HARTING Product Change Notification

PCN/18/024/C+N

Title: **Minior change of HARTING RJ Industrial® IP20 plug housing -
External**

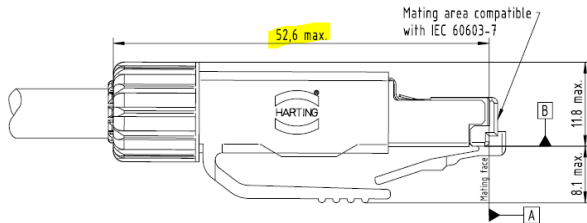
Because of a tool replacement process we carried out a minor redesign and improved the cable clamp of the plug hood. The new version now has the same cable clamp that we use with HARTING RJ Industrial® 10G series with a cable diameter from 4,5 to 9 mm. This is an additional improvement of this very successful product series.

The pictures above show the old and the new design. The new design can now also be equipped with the colour clips 0945 850 0001 - 0945 850 0010.

Old design

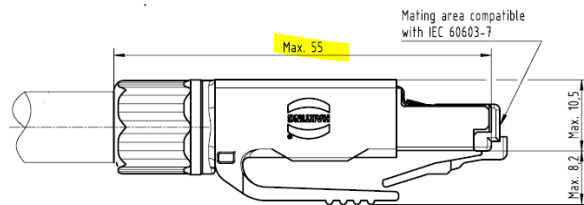
The dimensions are mainly identical. Only the total length has increased by about 2,4mm. See the drawings below.
